PRINCIPLE DESIGN DEVELOPMENTS KEY

PROJECT
RYLANDS BUILDING, MANCHESTER

TITLE
COMPARISON PLAN ROOF

ISSUE FOR
PLANNING DOCUMENT

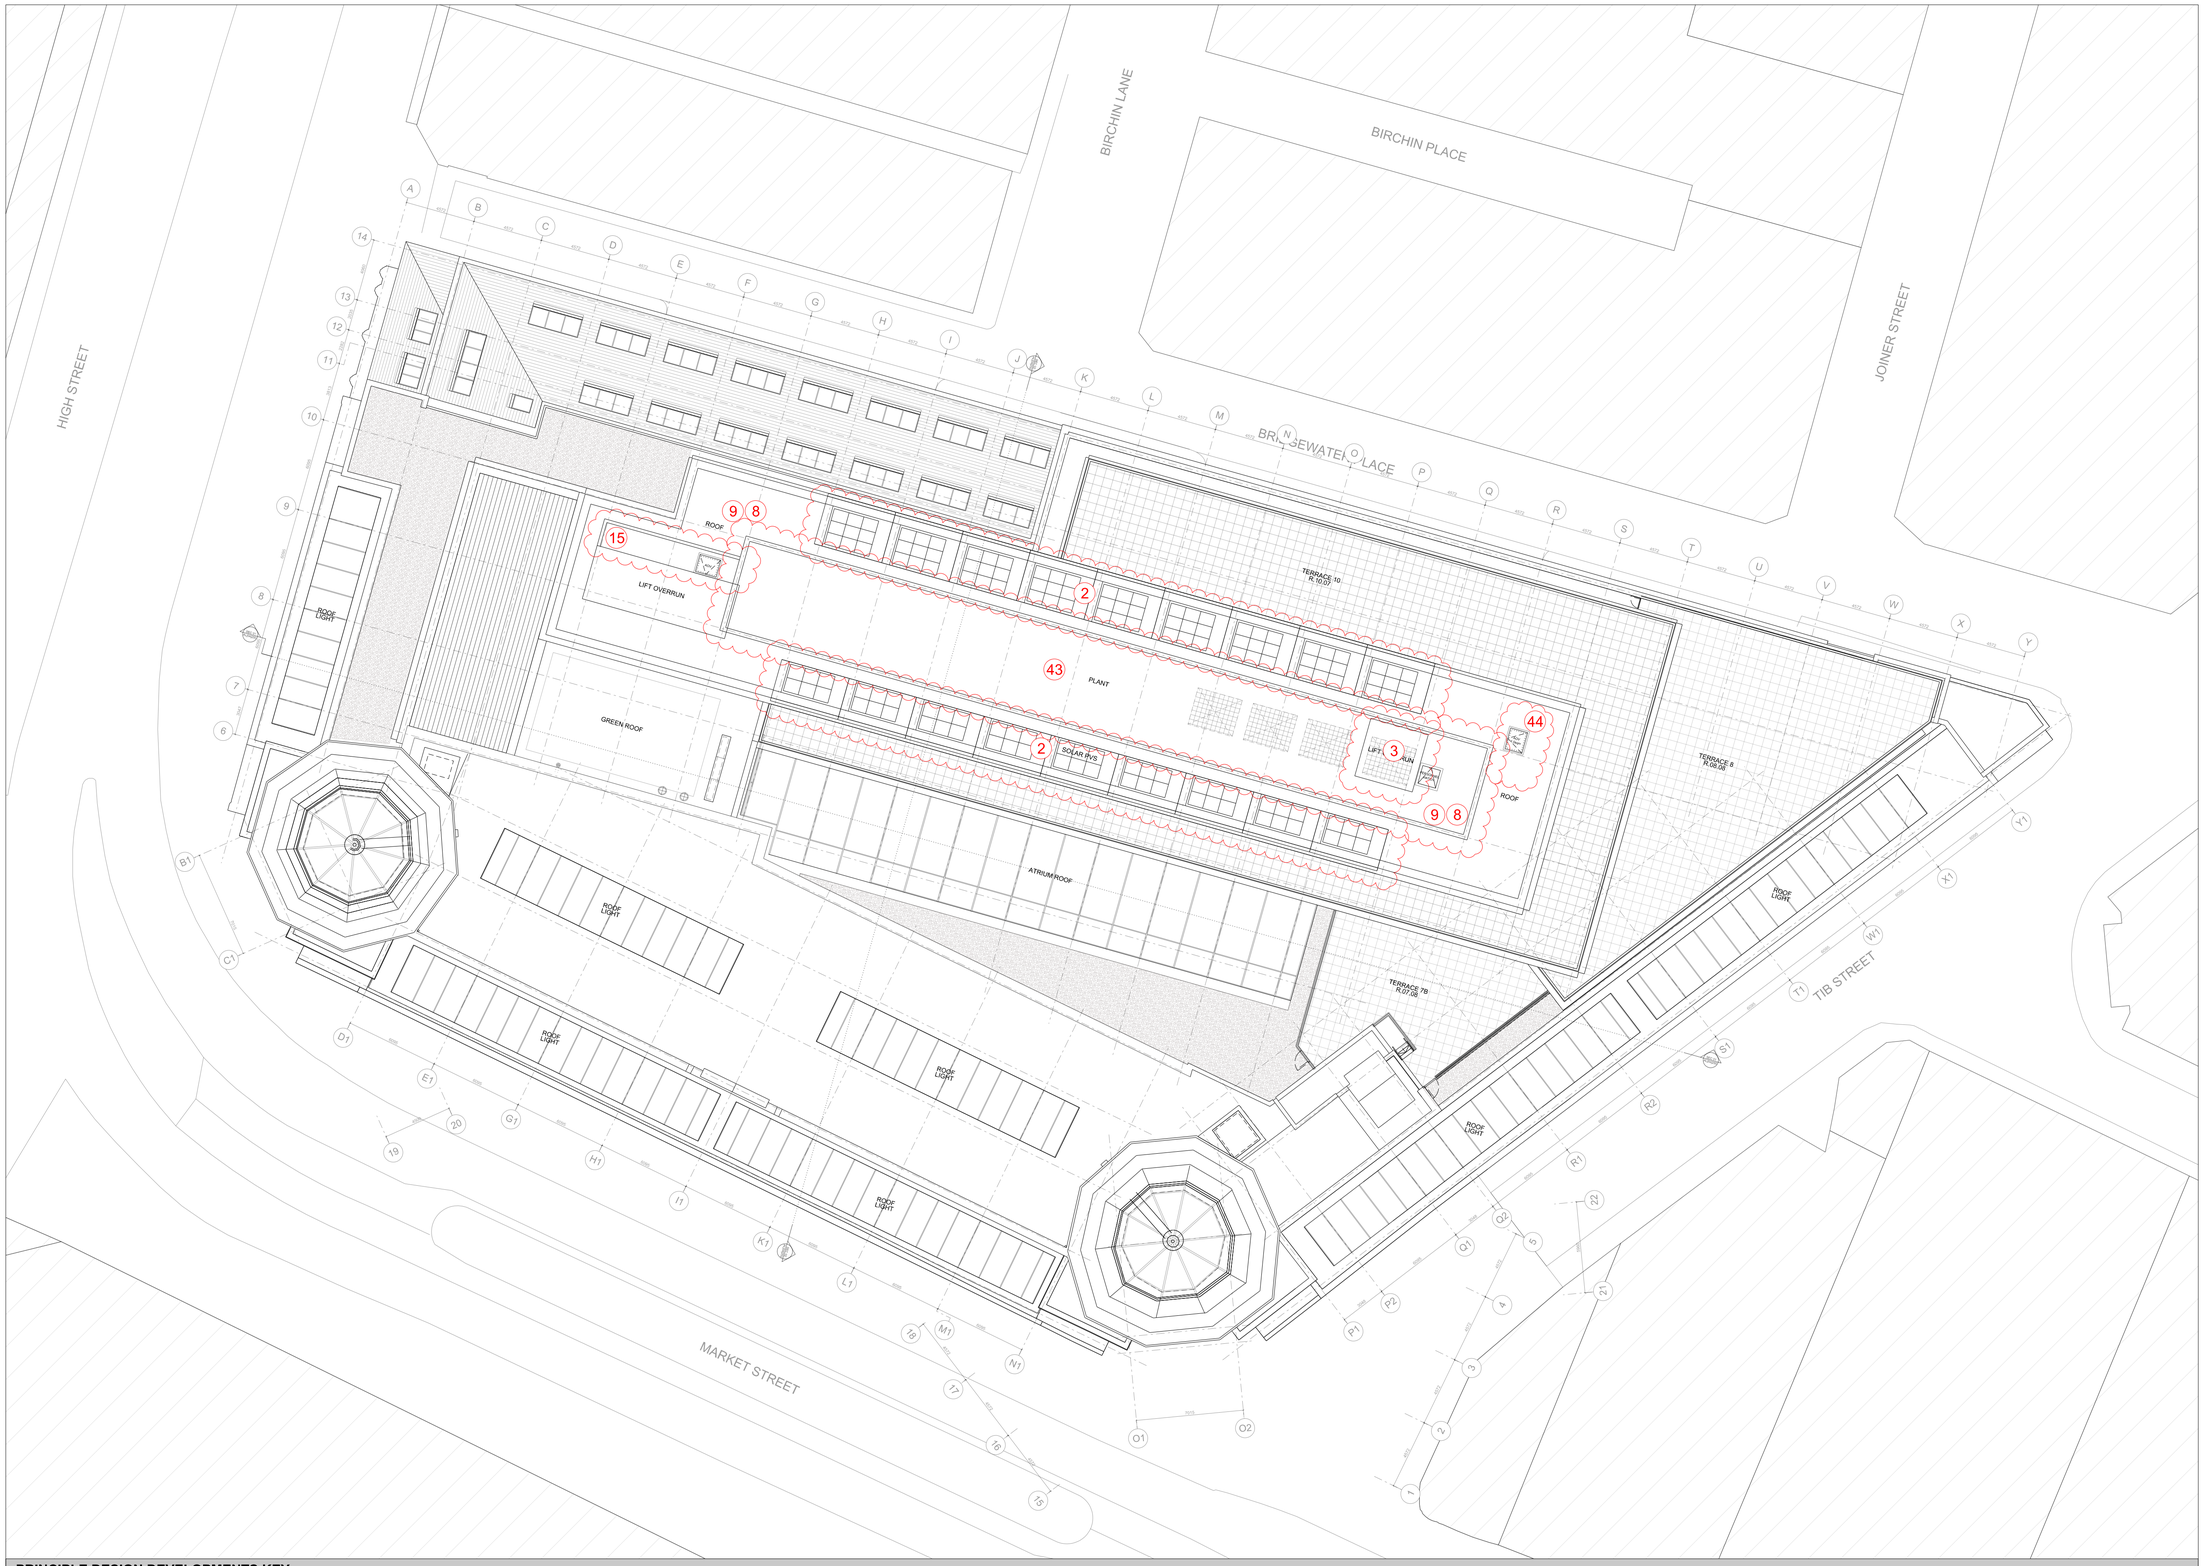
1. Double-mullions & Parallel Opening Vents omitted from extension elevations
2. Saw-tooth roof profiles reduced in number & length. Sawtooth structures to carry PV panels only, thermal envelope now at roof slab level.

3. Core 2 lift overrun height lowered within Roof Plant enclosure due to VRF MEP strategy.
4. Glazing sections to Atrium simplified.
5. Terrace 7A omitted. New back-painted glass screen to accommodate new VRF MEP servicing strategy at existing roof level. PPC vent louvres to lid, & to base of West elev, concealed behind main stone parapet.

9. Roof-plant enclosure reduced in width & lengthened to GL. H to accom. VRF MEP strategy. PPC vent louvres to base of South & North elevs concealed by sawtooths.

15. Lift overrun wall widened to conceal adjacent plant.
16. Protected Lobby update.
17. Store area adjusted.
18. Lift 8 omitted. Void/Store/tbc
19. Drop shaft relocated.

40. Green roof to flat roof of L7 link.
41. Ducting terminations in aesthetically coordinated metal sheathing.
42. Renewables omitted @ L7 roof.
43. Horizontal plant-screen fins omitted.

44. Overrun of Lift 10 removed.
